Clarifications and Corrections

AMENDMENT NUMBER 8 TO RFP-623-P-00-06-00001
USAID/SUDAN FIELD OFFICE COMPOUND RENOVATIONS IN
JUBA, SOUTH SUDAN.

This amendment eight does the following:

- 1) Announce to the potential offerors answers to questions emanating from the solicitation; provide clarifications and corrections; provide bills of quantities for exercise room and locker room bathroom.
- 2) Potential offerors should visit the following link to access these information :
www.usaidkenya.org/buproc/questionsandanswers.html.

Single stretcher course

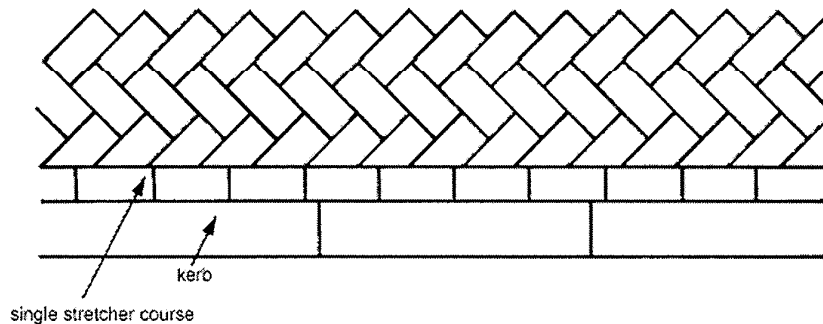
1. Concrete pavers will be 200 mm x 100 mm x 65 mm thick mm thick standard concrete blocks. A laying course of 50 mm of sand will be required. British Standards will be followed for laying the blocks. Contractor will allow for removal and disposal of average of 100 mm of existing soil and replacement of 50 mm layer of sand (sand provided by USAID) over a 3000 square meter area for the total project before block laying. Every reference to Concrete Pavers 40 x 40 is to be replaced by standard concrete block pavers and the total area should not exceed 3,000 M². Allow 25 M³ for removal and replacement of soft soils. Most of the work will be done between existing curbs. This work can be done without machines except for the standard concrete block pavement vibrator and the block cutter or splitter. The *Herringbone at 45° to an edge* pattern will be used on the roads. *Use this pattern.*

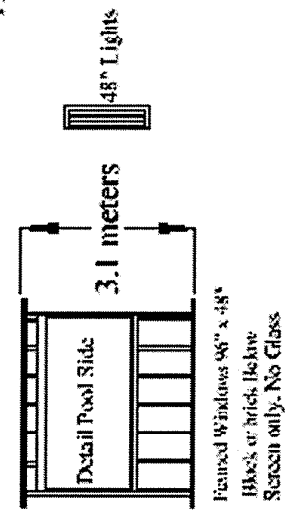
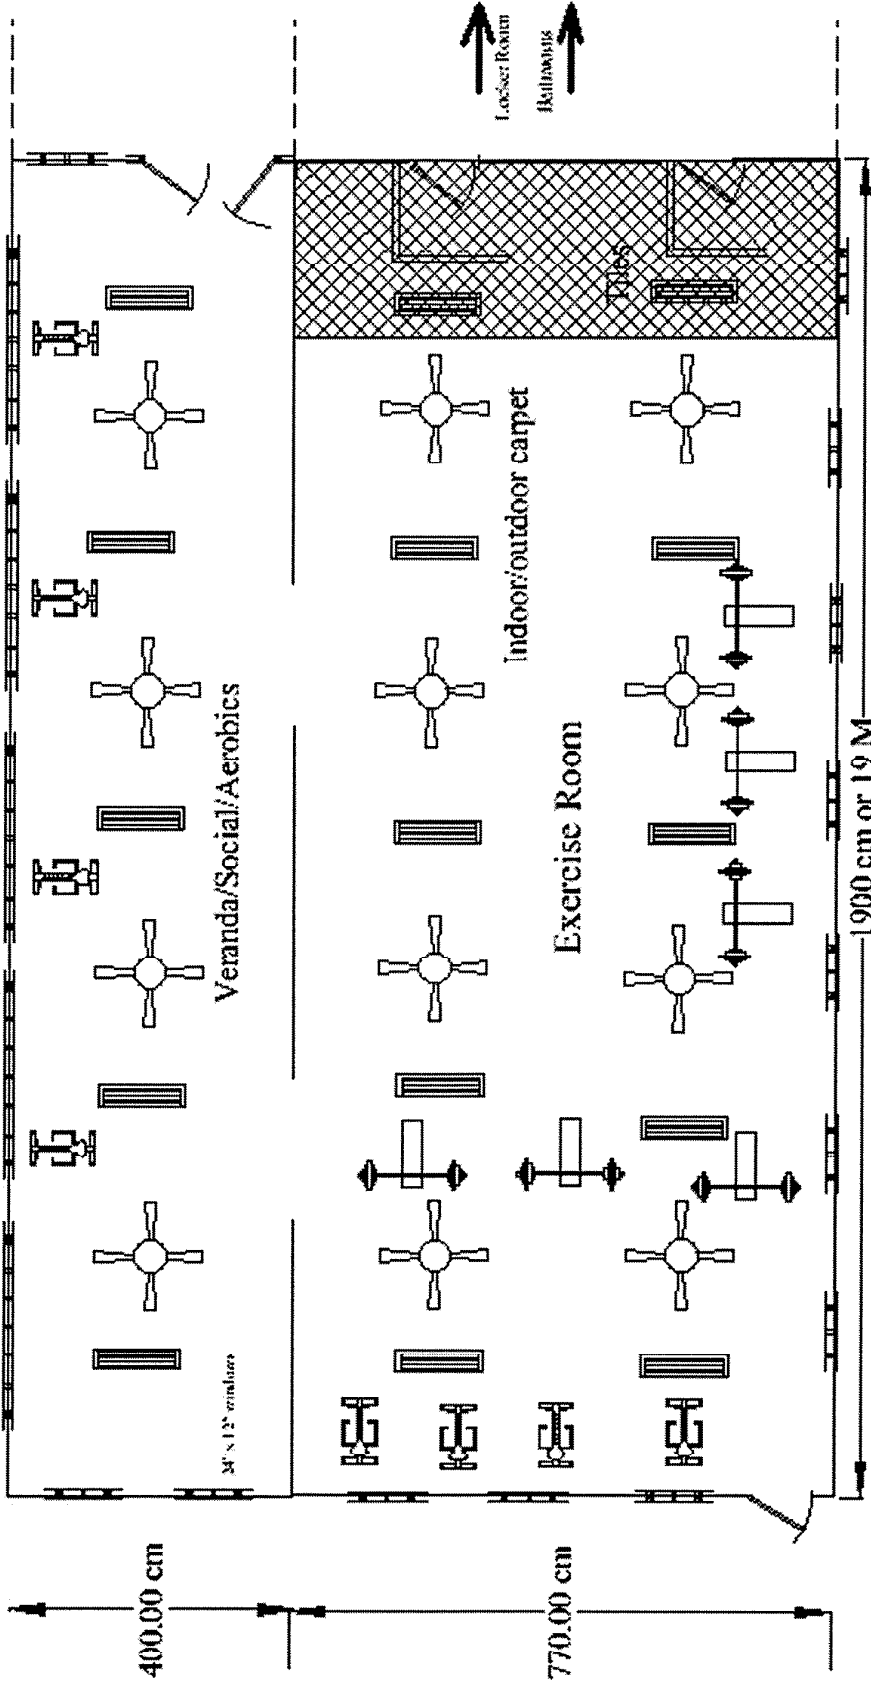
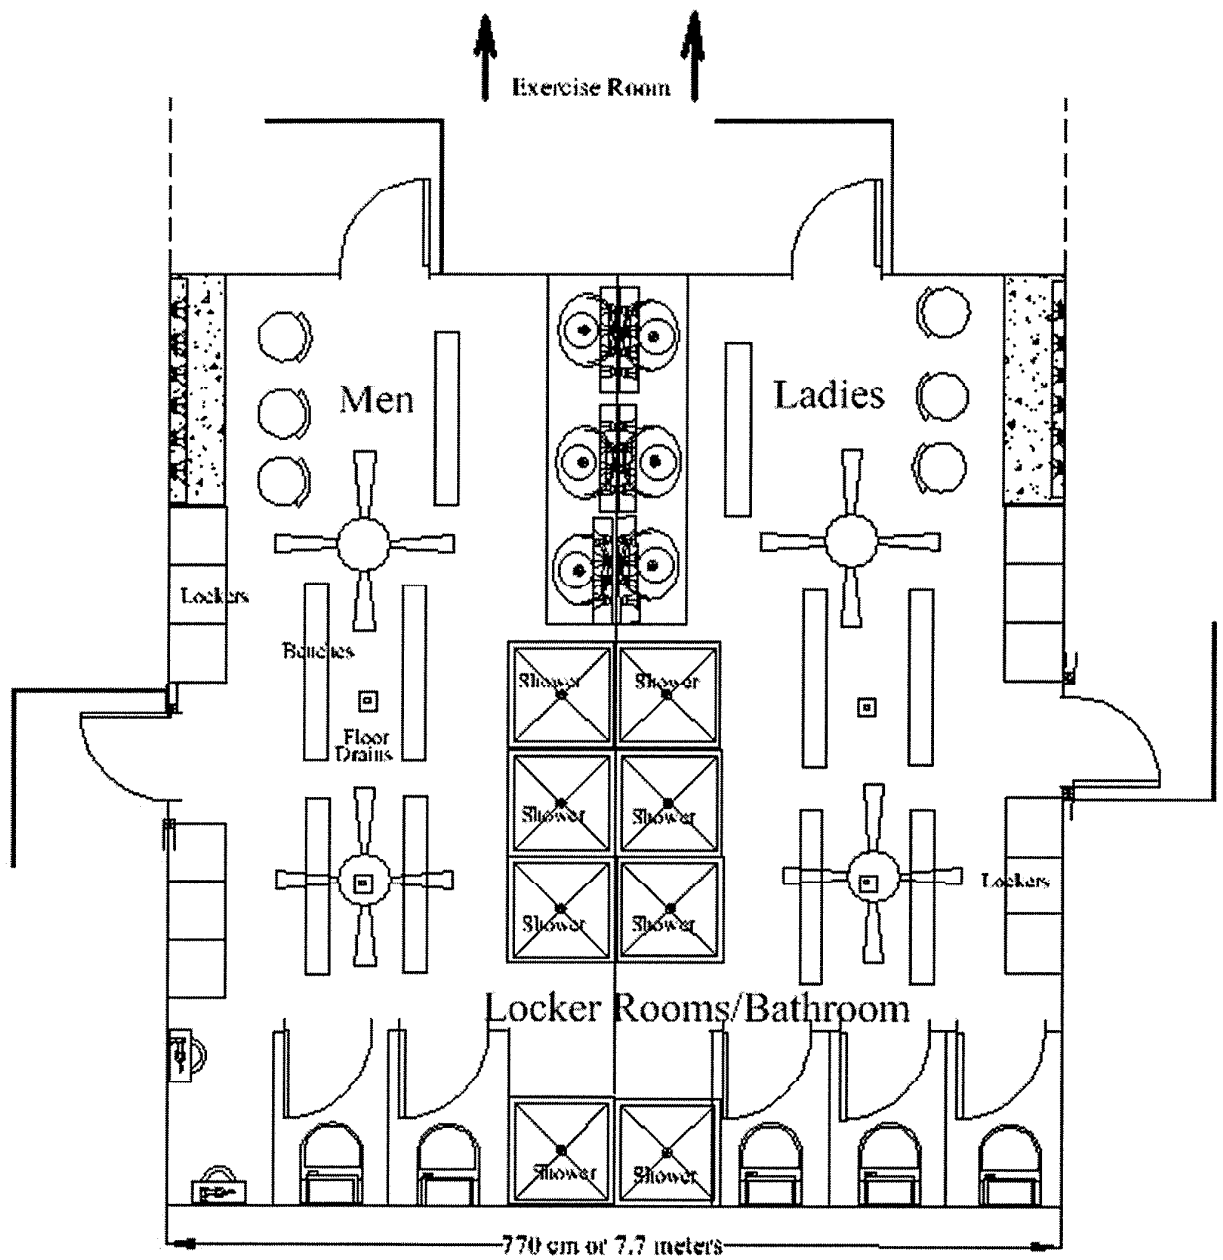
6. Add to Security Fence section the removal and disposal of existing security fence.
7. USAID will be supplying the shuttering for the concrete security wall anti-ram base. The contractor should be able to pour 20 linear meters of wall per day with this system. The shuttering system will be similar to www.wallties.com systems. USAID will provide oil for the formworks. There will be approximately 770 M³

of concrete in the security fences with about 43 tons of rebar. The Contractor should have a mixer capable of producing a minimum of 20 M³ of concrete per day. Contractor will be responsible for security of the formworks and return it to USAID in good condition. The Contractor will replace any missing items of the shuttering system.
